# **Williams AFB ST12 Fuels Spill Site Informal Dispute**

# ST12 Fuels Spill Site Dispute Overview

## Problems with Addendum 2 RDRAWP for EBR

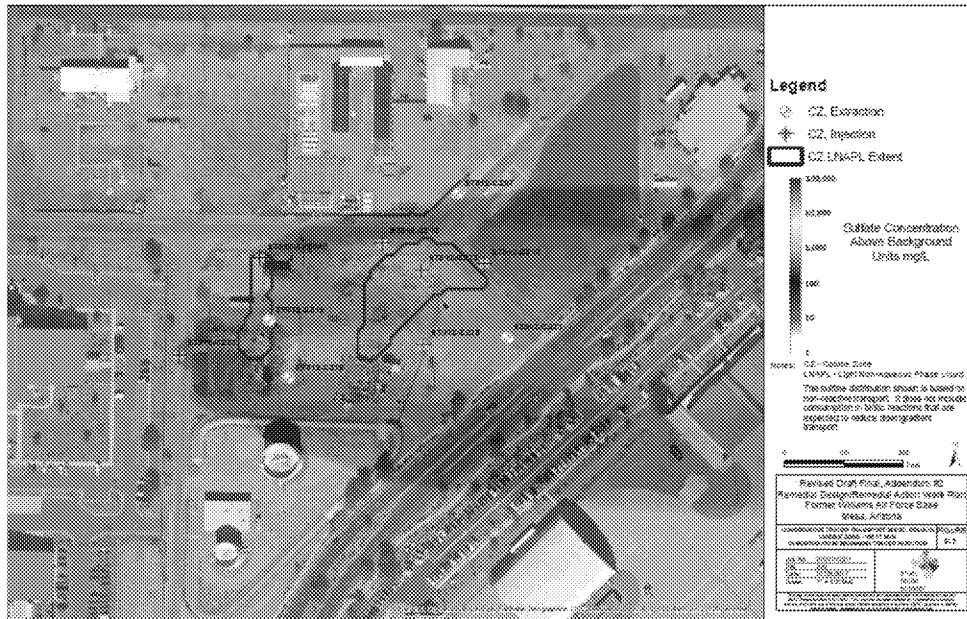
In many instances proposed extraction wells (shown in blue) are upgradient or side gradient of proposed injection wells (shown in green) with distances over 70 feet and no monitoring wells in between. Interpretation will be subject to many assumptions which may not be valid or accurate.

- Must provide containment for long term protectiveness; current plan allows injected sulfate amendment to migrate off site and degrade downgradient resources. Targeted treatment areas may not even be reached.

3. **Robust Monitoring Plan**: Develop a monitoring program using the checklist guidelines provided by the Agencies. Because AF rejected the option of doing a pilot test, each of the 32 treatment ovals from the May 2017 BCT meeting need at least 1 monitoring well to be able to evaluate ( see next slide)
